## HISTORIC AND DESIGN REVIEW COMMISSION

### Agenda Item No: 15

**HDRC CASE NO:** 2016-172  
**ADDRESS:** 283 W MARIPOSA  
**LEGAL DESCRIPTION:** NCB 9012 BLK 6 LOT 89 90 AND W 12.50 FT OF 88  
**ZONING:** R4 H  
**CITY COUNCIL DIST.:** 1  
**DISTRICT:** Olmos Park Terrace Historic District  
**APPLICANT:** Edward Pape  
**OWNER:** Christine Catsifas  
**TYPE OF WORK:** Expand driveway, replace garage door  
**REQUEST:**

# PLOT PLAN

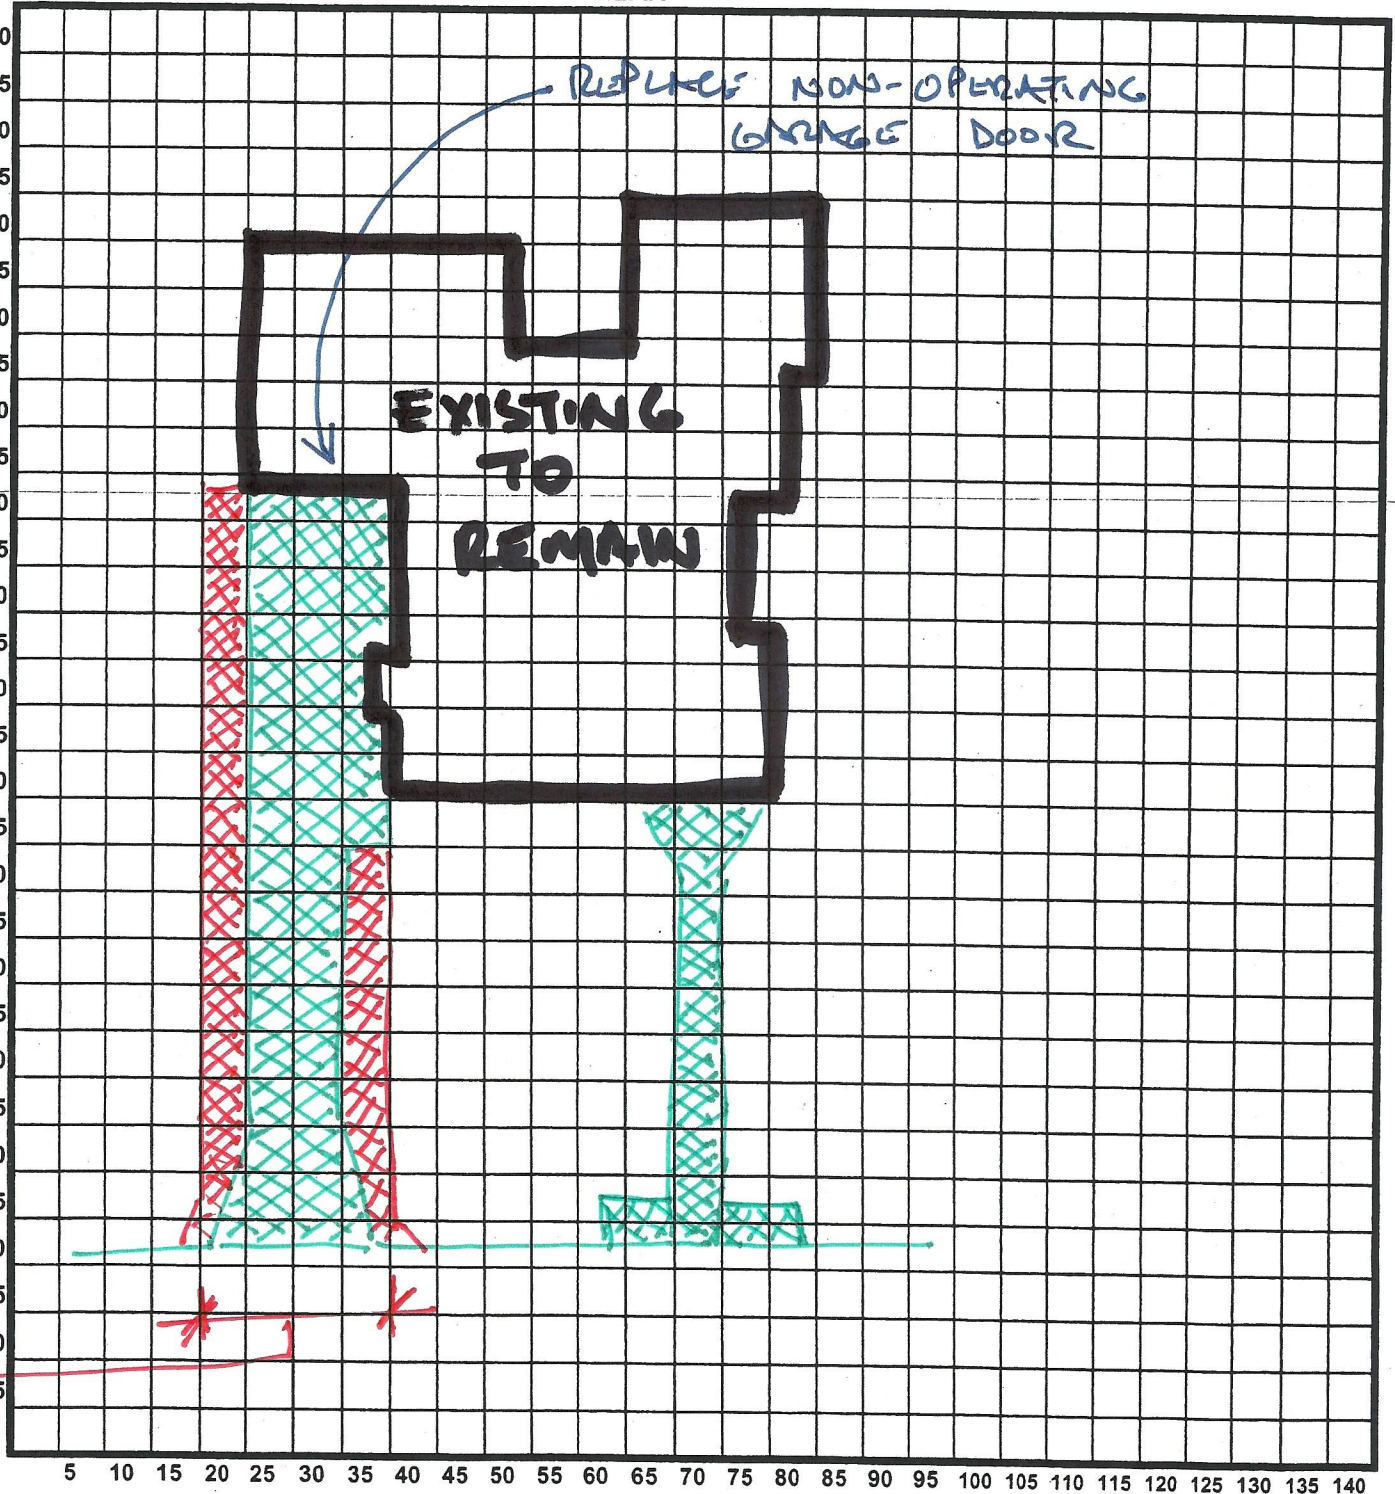
- b. The applicant is proposing to tear up existing 10' concrete driveway and repour a 17' wide concrete driveway, which is not consistent with the Guidelines for Site elements. The Guidelines state that historic driveways are typically no wider than 10' and that new driveway configurations should be similar to what is found in the district. Staff made a site visit on May 6, 2016, and found that driveways in Olmos Park Terrace Historic District typically are 10' to 15' wide. Staff recommends that the applicant not expand the driveway to the corner of the house, but towards to left property line.

Staff does not recommend approval of item #1 or #2 based on findings a through b.

GARAGE DOOR REPLACEMENT (PROPOSED)

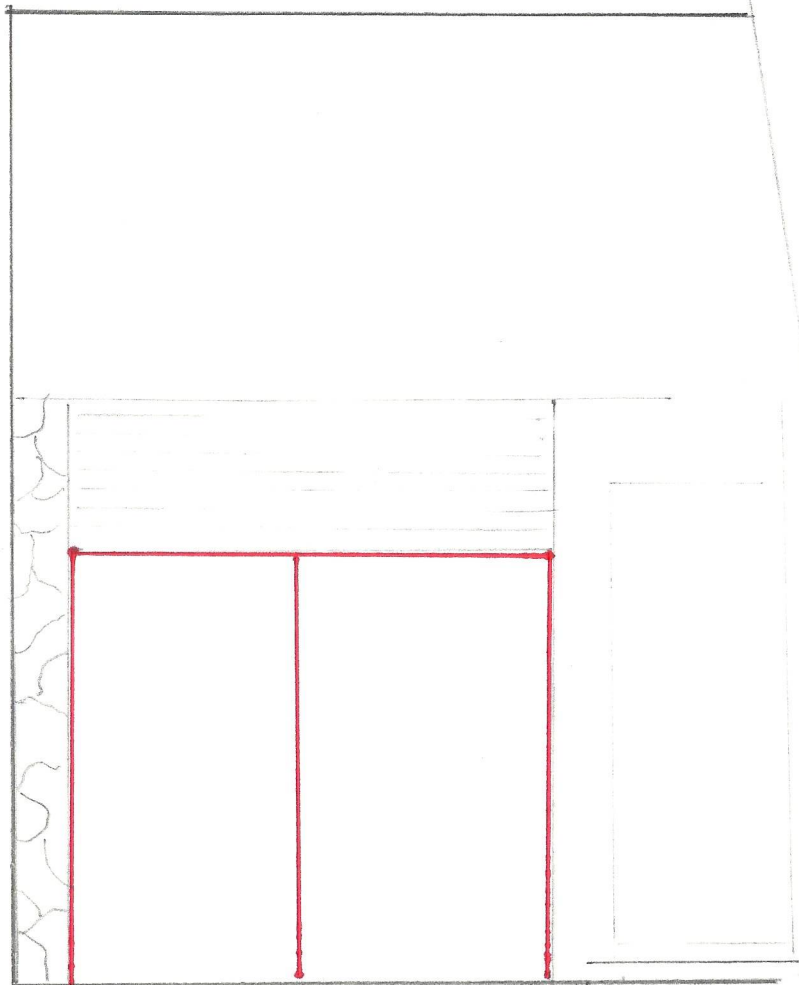
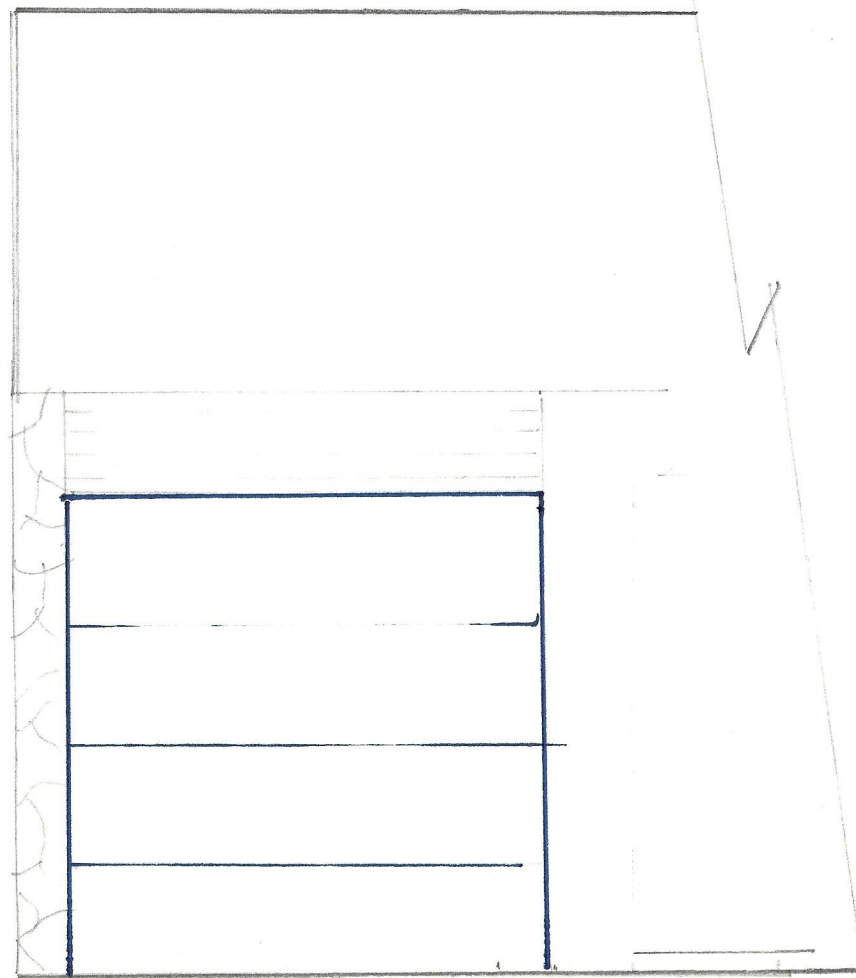
- a. The applicant is requesting to replace existing wooden swinging garage door with an overhead paneled steel garage door painted to match existing door and trim. This is not consistent with the Guidelines for Exterior Maintenance and Alteration 6.B., which states that doors should be replaced with in-kind materials.
